# STAFF REPORT

RE: **21 Quay Road-Truman Waterfront Park; PAL Building, Horse Stables and Athletic Field**  
**(permit application # T2018-0025 and T2018-0026)**

FROM: Karen DeMaria, City of Key West Urban Forestry Manager

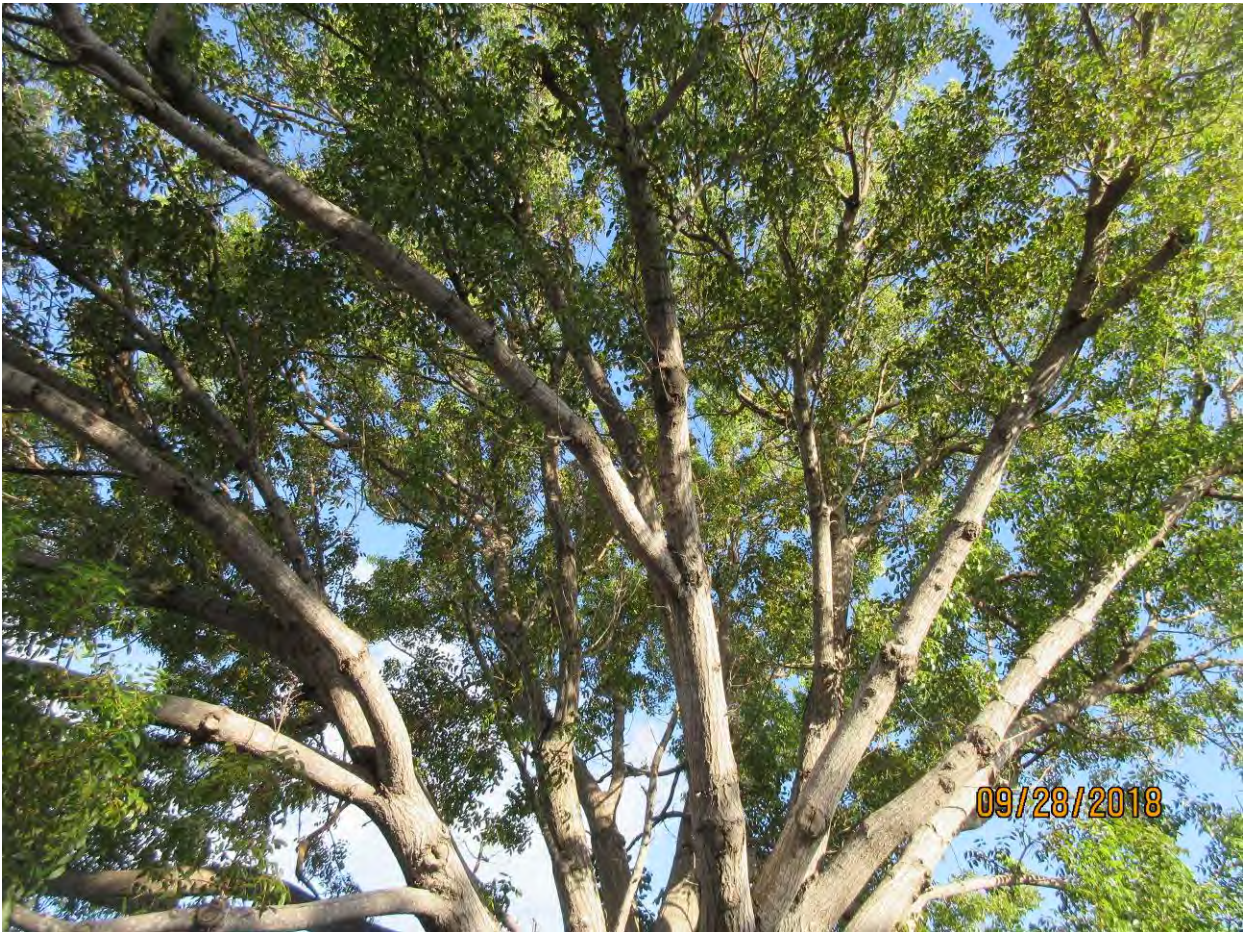
Trees that were originally approved to be transplanted but now are requesting removal-based on the new number system: 4-Gumbo Limbo (#79, #81, #83, and #Q), and 2- Sea Grape (#70 and #82). One tree was originally approved to remain but now is requesting removal: 1-Mahogany tree (#100).

**Tree #86 and #87**

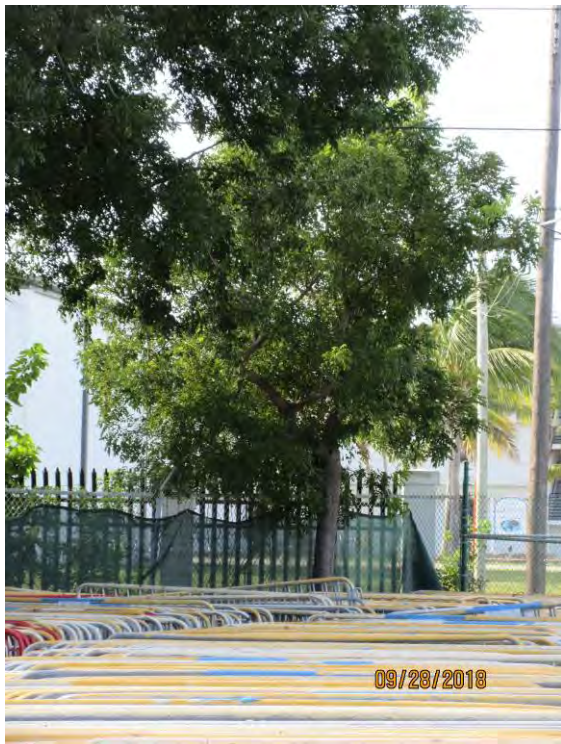
**Tree #86 and #87 (old #17A and #17B)**
